Drain: CLARIDGE FARMS DRAIN **Drain #:** 243
Improvement/Arm: CLARIDGE FARMS - SECTION 4
Operator: JOH **Date:** 11-19-03
Drain Classification: Urban/Rural **Year Installed:** 1992

Drain-Improvement: CLARIDGE FARMS DRAIN - CLARIDGE FARMS - SECTION 4

RE: Claridge Farms Drain-Section 4

Re: Claridge Farms Drain - Sec. 4

STORM SEWER RECORD DRAWING

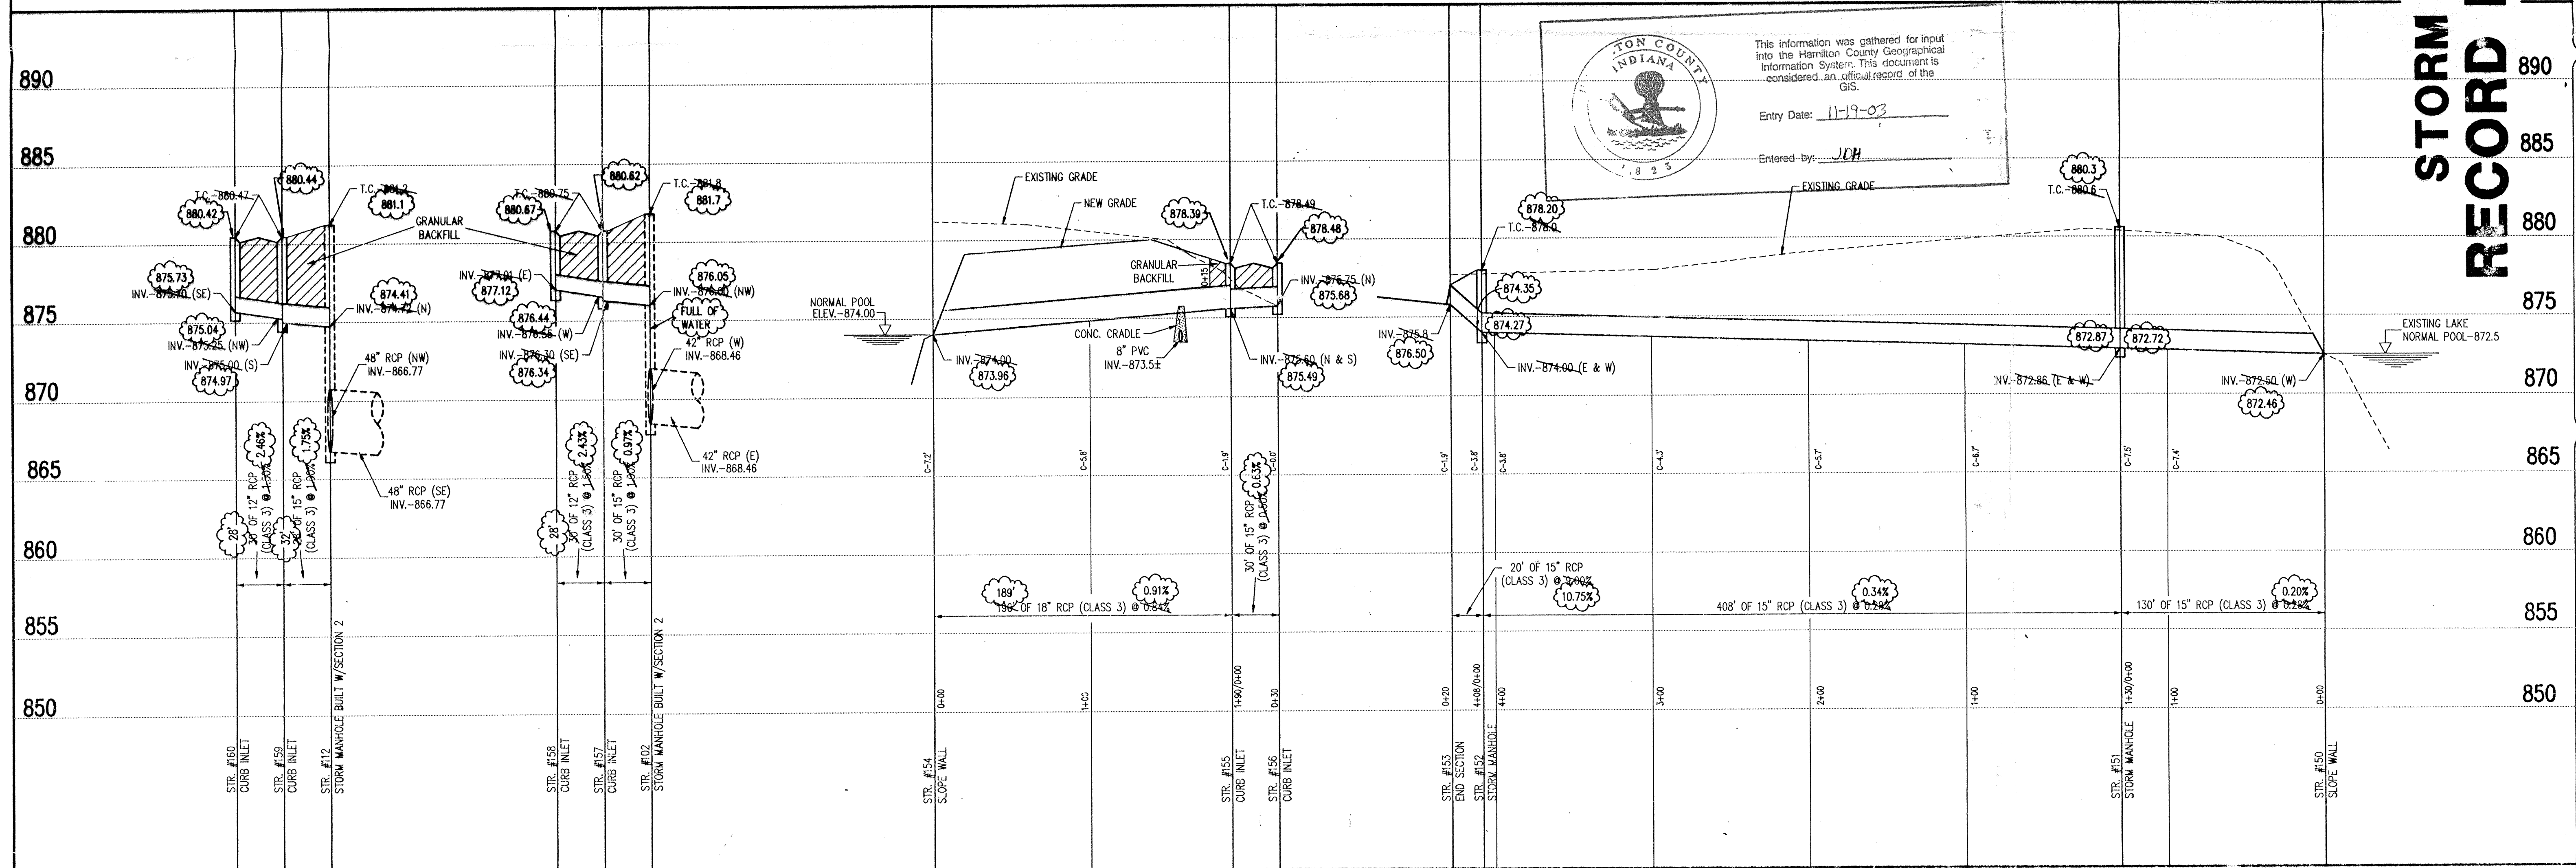
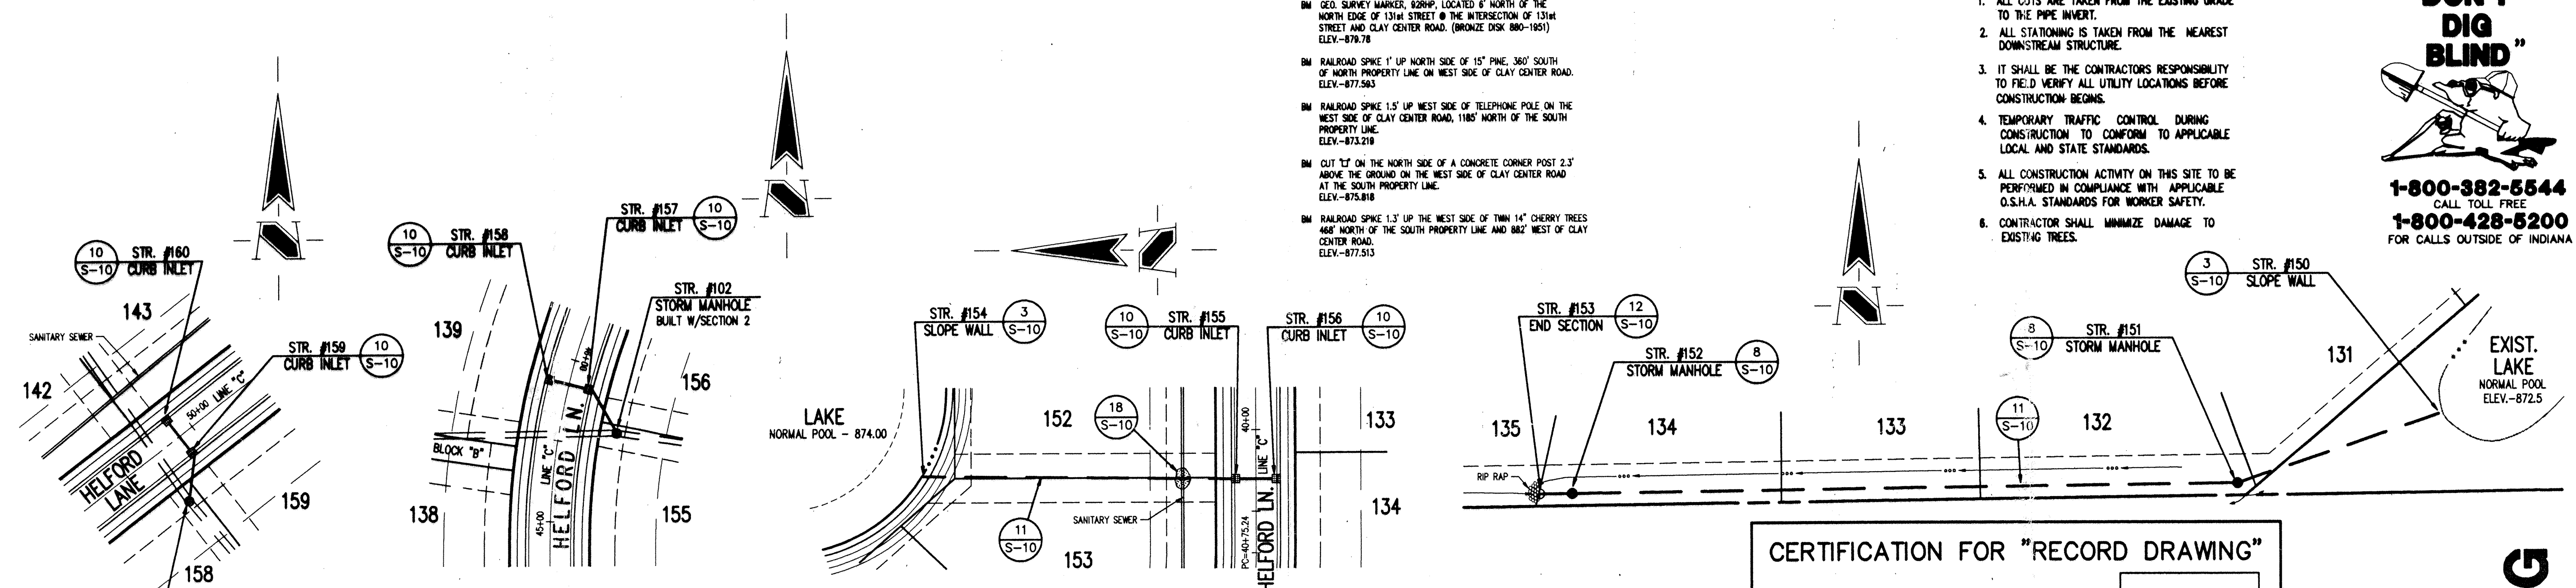
During construction, changes were made to the drain which will alter the plans submitted with my report for this drain dated November 16, 1992. The changes are as follows:

Str 155-154 consists of 18" RCP which was shortened from 190 feet to 189 feet.

Str 157-158 consists of 12" RCP which was shortened from 30 feet to 28 feet.

Str 112-159 consists of 15" RCP which was lengthened from 28 feet to 32 feet.

Str 159-160 consists of 12" RCP which was shortened from 30 feet to 28 feet.

The correct total of 6" ssd is 5239 feet. The underdrain across lots 132 to 138 consists of 4" ssd. This was noted on the original report as 6". The total length of 4" ssd is 1175 feet.

The length of the drain due to the changes described above is now 7309 feet.
